HydroQuest

April 25, 2016

Comments of Paul A. Rubin of HydroQuest regarding the January 26, 2016 Remedial Action Work Plan (RAWP) for 109-125 Marbledale Road, Tuckahoe, New York, at Brownfield Cleanup Program Site #C360143 (a.k.a. Former Marble Quarry Landfill Site) prepared by HydroEnvironmental Solutions, Inc.

Figure 1. Bronxville to Scarsdale Geologic Cross Section.

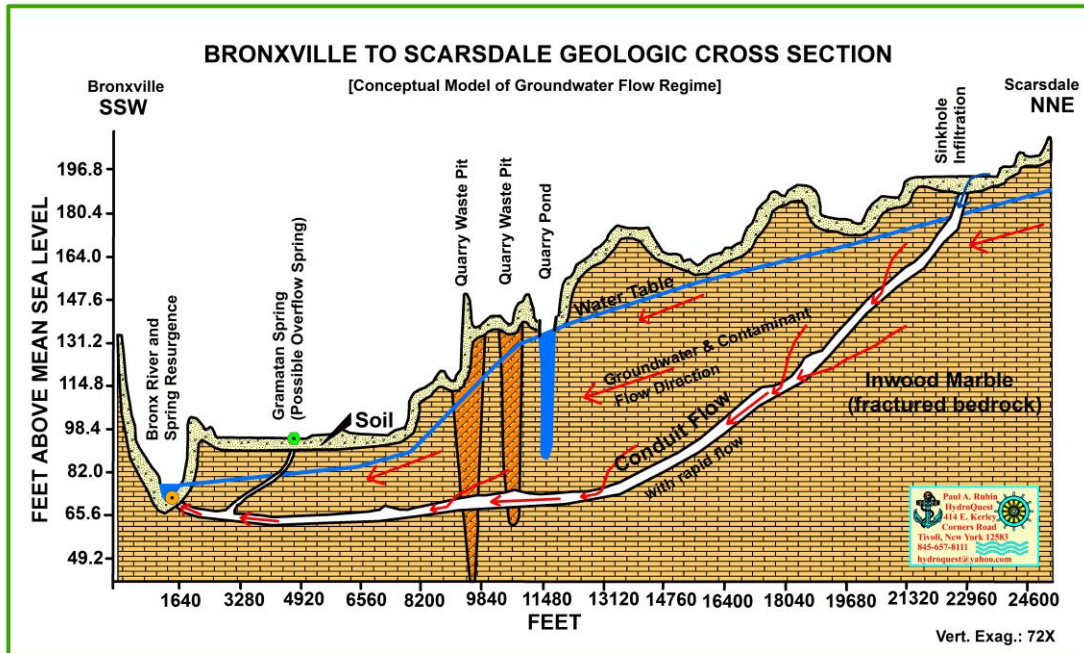
At the April 14 meeting, NYSDEC stated that the 555-foot deep Kings Electronics well found “no marble” and only some fractures at depth. Based on this, NYSDEC concluded that the HydroQuest hydrologic model depicted on the next page is not correct. NYSDEC continued and stated that the “marble is probably not continuous”. Statements that contradict the work of recognized geologists without providing rigorous supporting documentation have no place in important RAWP decisions. NYSDEC further stated at the April 14 meeting that there is “no significant indication that contaminated groundwater is migrating offsite.” This is not surprising because they did no offsite testing.

The hydrologic flow regime presented on the following page is well-supported based on known, mapped, bedrock geology, physical features present in the area, and accepted hydrogeologic principles of groundwater flow through porous, fractured and karstic media (Figure 1). Figure 2 depicts an impossible hydrogeologic scenario whereby no groundwater or offsite contaminant transport can occur. While NYSDEC may believe that there is “no significant indication that contaminated groundwater is migrating offsite”, the laws of physics and hydrogeology dictate that this **must** be occurring. Figure 3 illustrates the location of the valley axial profile line used to construct Figures 1 and 2.

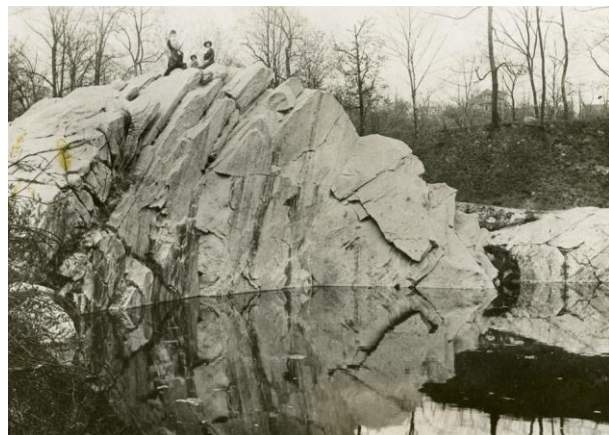
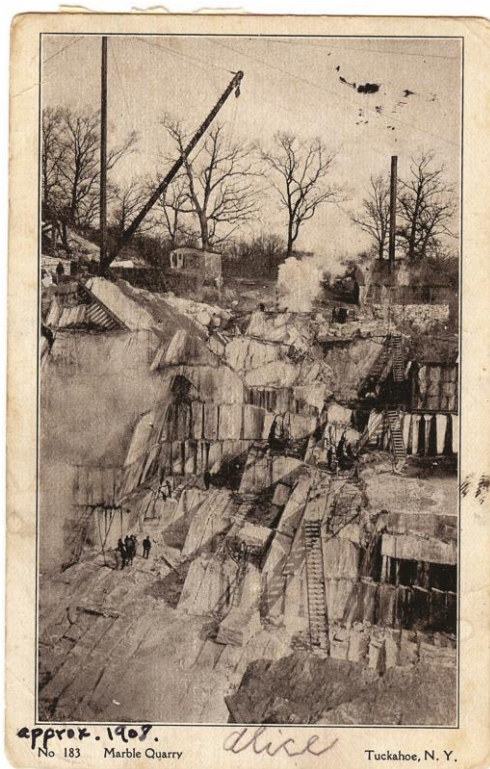
Importantly, NYSDEC has used findings of the Cody Ehlers Group (1999; Summary of Environmental Conditions; Kings Electronics Co., Inc.; 40 Marbledale Road; Tuckahoe, New York) to erroneously “document” that karstic conduits do not exist in the area. As discussed above, the deep production well at the Kings Electronics site (approximately 574 feet south of the Brownfield site footprint in the low valley floored with the Inwood Marble; Figure 4) is largely if not entirely constructed within the schistose Manhattan Formation. This is consistent with downhole camera observations, as well as penetration of sloping (and possibly completely removed) overlying marble beds.

Figure 6. The structurally weak valley occupied by the Marbledale Road waste site and Kings Electronics site is flanked by erosion resistant schist and gneiss ridges. Groundwater flow is laterally constrained by impermeable schist and gneiss units.

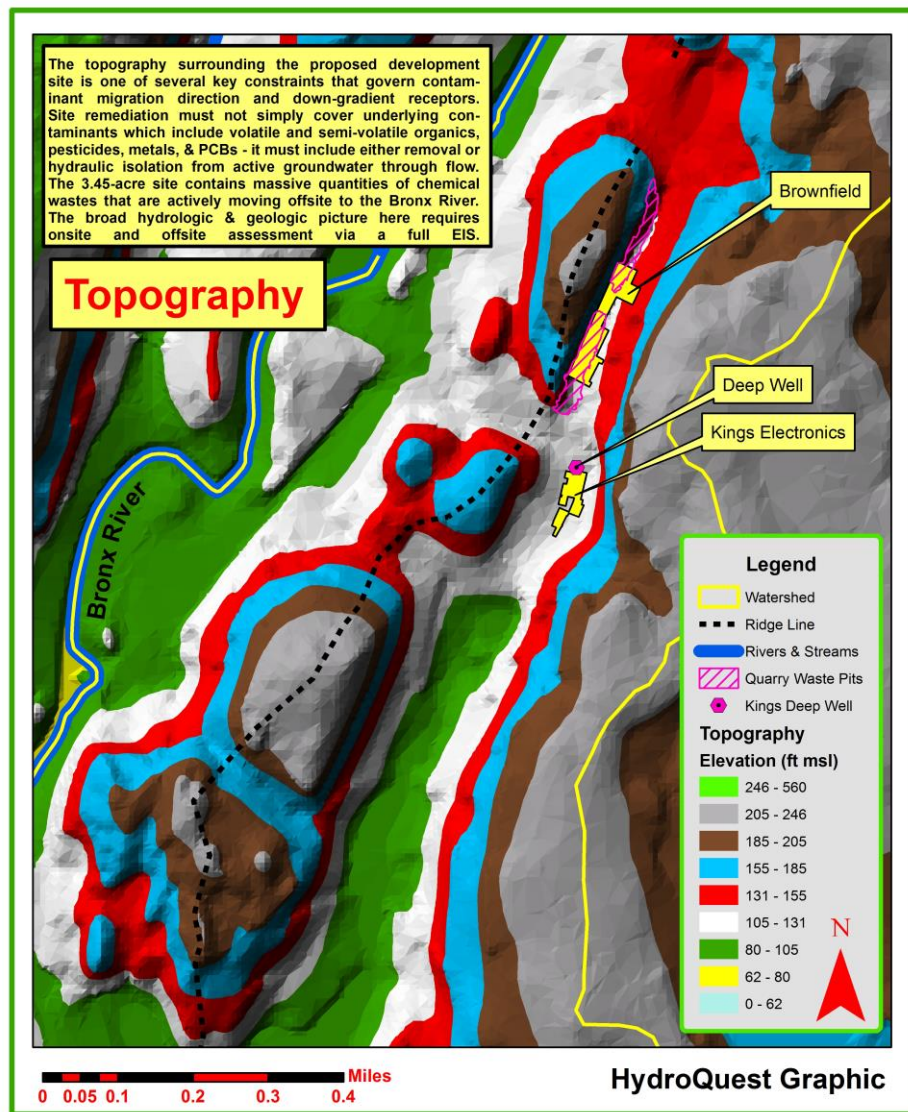
As discussed above, the Kings Electronics deep production well is largely or completely constructed in Manhattan Formation schist. Geologically, this schist was most likely penetrated beneath overlying and dipping Inwood Marble beds formerly present in a quarry. Figure 6 shows the topographic setting with the erosion weak Inwood Marble present as a valley former, flanked by resistant ridge-forming schist and gneiss formations to the east and west, respectively.

Figure 7. “Remedial” actions within the footprint of the Marbledale Quarry chemical waste site would fail to address most contamination.

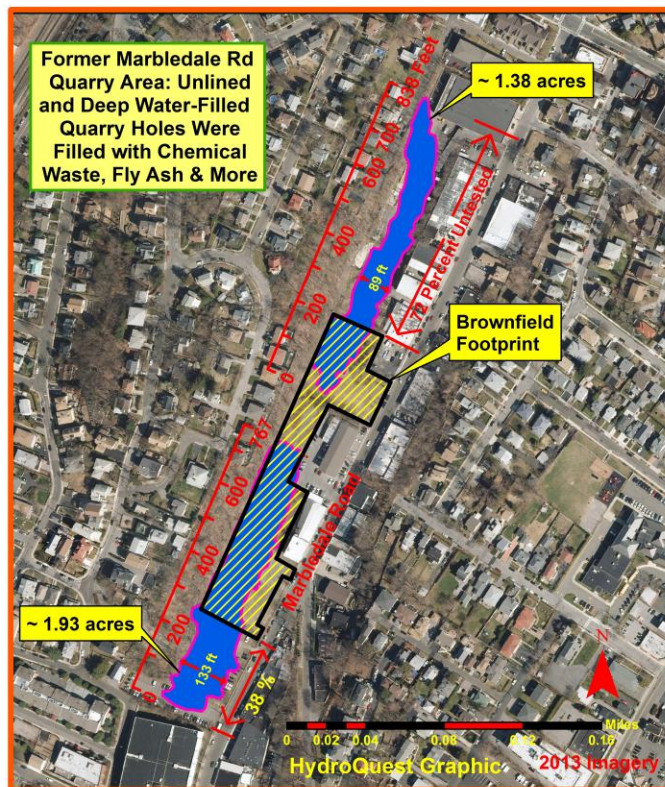
Delineation of conduit flow paths and down-gradient receptors in karst settings requires characterization via non-traditional accepted methods (e.g., ASTM standards; tracer testing) that acknowledge that wells are most often not appropriate because they seldom encounter the rapid flow portions of karst aquifers. To date, the applicant has failed to characterize the conduit and non-conduit portions of the carbonate aquifer underlying the site, groundwater flow paths, off-site contaminant presence or absence, and down-gradient receptors. All told, the applicant has barely addressed/assessed the shallow fill aquifer present on the proposed hotel site, much less recognized and evaluated the broader hydrogeologic setting and off-site contaminant receptors. Assessment of potential remedial options, as are contemplated in the RAWP, should not be conducted until after the full vertical and horizontal extent of contamination have been characterized. Clearly, as seen in Figure 7 below, the limited waste site testing conducted to date at the proposed Brownfield development site is little but a piecemeal attempt to examine a much larger inactive hazardous waste site.

As discussed above and in previous HydroQuest reports, none of the remedial actions proposed, including the Alternative B remedy, will do anything to stop contaminants from migrating offsite. The options put forth will do nothing to stop or permanently thwart offsite contaminant migration. Instead, accepting a remedy to allow a single developer to advance his project may ultimately make it impossible to conduct comprehensive testing and remediation of the entire chemical waste site as is depicted in Figure 7 above. In many ways, the entire RAWP is analogous to illegal spot zoning.
